Machine	TASKI swingo 1650, 1850, XP
Subassembly	Charger

New charger generation

GTS Newsletter

2015 / 12E

Charger (4127084 / 18602-53)

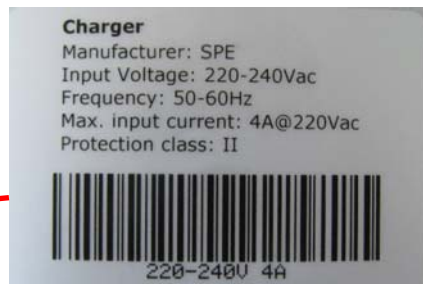
A new charger generation (plug and play principle) will be introduced. The existing MEG charger will be replaced by a new, enhanced SPE charger. The new equipment includes an Anderson plug to connect the battery side, a plug for the power cable and a 8-Pin plug for the control cable.

If a defective old charger needs to be replaced by a charger of the new pluggable generation, then the plugs need to be cut and the wires have to be connected with connectors. An adapter cable to connect the old 6 pin plug with the new 8 pin plug of the charger has been integrated into the set. We have as well enclosed to the charger a detailed installation instruction how the modification (old - new) needs to be done.

The charger (4127084/18602-53) includes specification label, connectors, connection cable as well as an installation instruction (complete adapter kit). For legal reasons the specification label needs to be affixed to the machine (see picture below). With this kit the new charger will be fully backwards compatible.
